GOVERNMENT OF THE DISTRICT OF COLUMBIA
DEPARTMENT OF TRANSPORTATION

MEMORANDUM

SUBJECT: ZC Case No. 17-19 – 5110 Nannie Helen Burroughs Avenue NE (Deanwood Town Center)

Figure 1 – Ground Floor Plan (Source: Applicant Plan Set, Sheet A-01, 12/22/17)

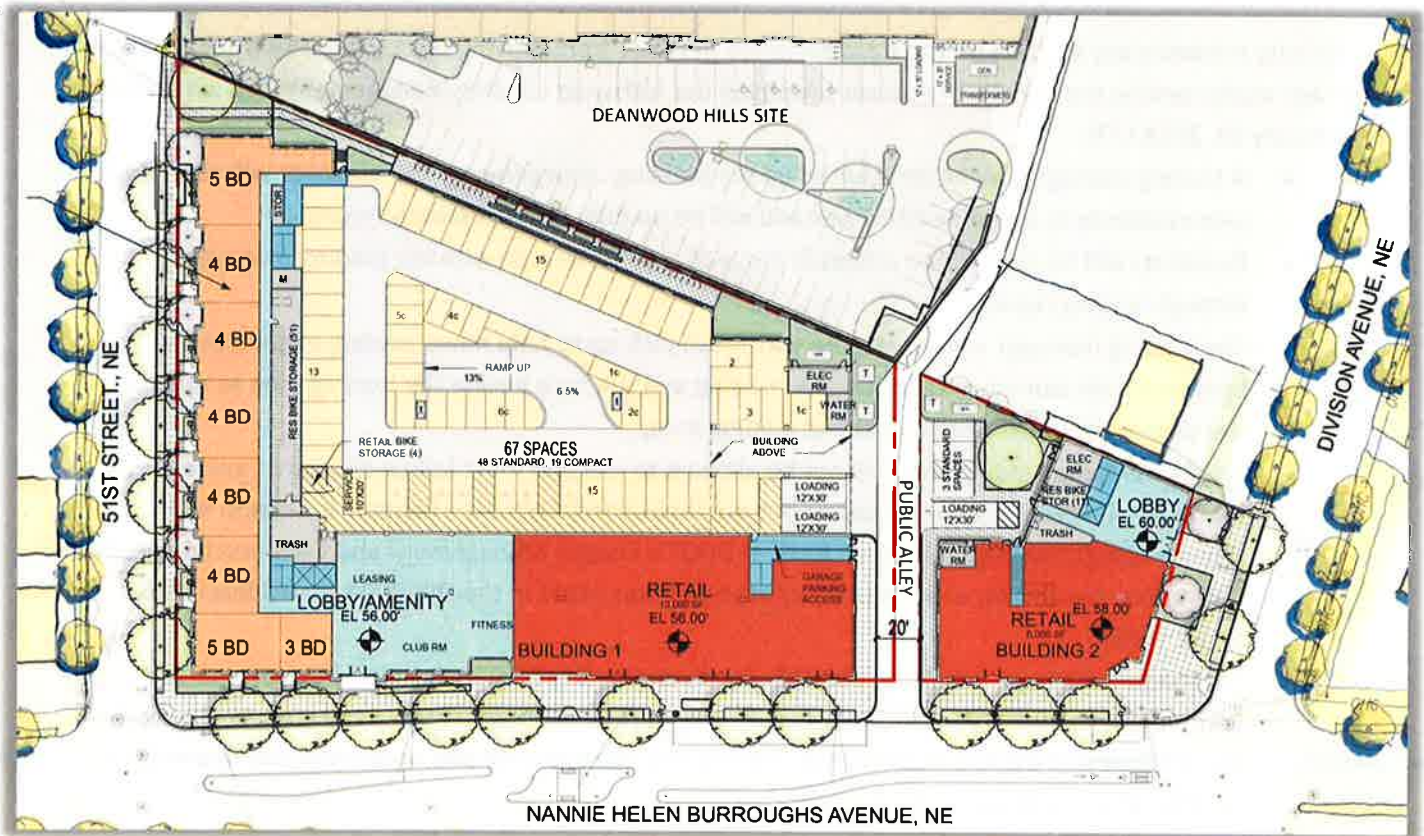
- The retail entrance at the western building on Nannie Helen Burroughs Avenue NE is shown as having steps and an ADA ramp. All building entrances should be at grade so as to maximize green space and minimize paving in public space;

- The locations of the 18 required short-term bicycle parking spaces (9 inverted U-racks) are not currently shown on the December 22, 2017 plan set. These racks should be placed in the ‘furniture zone’ on public space with most placed near the retail entrances;

- Move the bioretention planters on the northern side of Nannie Helen Burroughs Avenue NE to edge of curb to allow for a wider and straighter pedestrian clear path;

- The proposed sidewalk on 51st Street NE is currently shown as tapering at the northern end of the site. This should be widened to a minimum of 6-foot plus tree boxes and street trees installed; and

Pedestrian access for the retail portion of the project will be via entrances on Nannie Helen Burroughs Avenue NE. Residents of the property may either access the buildings via entrances on 51st Street, Nannie Helen Burroughs Avenue, and Division Avenue NE. Figure 1 below shows the site layout of the Deanwood Town Center project. It is noted that the retail entrance at the western building on Nannie Helen Burroughs Avenue NE is shown as having steps and an ADA ramp. All building entrances should be at grade so as to maximize green space and minimize paving in public space.

While the preliminary public space plans, shown in Figure 1 above, are generally consistent with DDOT standards, there are several considerations that need to be incorporated and items to be reviewed in greater detail during the public space permitting process:

- Move the bioretention planters on the northern side of Nannie Helen Burroughs Avenue NE to edge of curb to allow for a wider and straighter pedestrian clear path;
- There are three (3) total curb cuts proposed to be closed on Nannie Helen Burroughs Avenue and Division Avenue NE;
- The existing alley curb cut is proposed to be widened from 12 to 20 feet;
- All building entrances on Nannie Helen Burroughs Avenue NE should be at-grade so as to maximize green space and minimize pavement proposed in public space;
- The proposed sidewalk on 51st Street NE is currently shown as tapering at the northern end of the site. This should be widened to a minimum of 6-feet plus tree boxes and street trees installed; and
- Determine final locations for the short-term bicycle spaces (inverted U-racks) in the ‘furniture zone’ within public space.
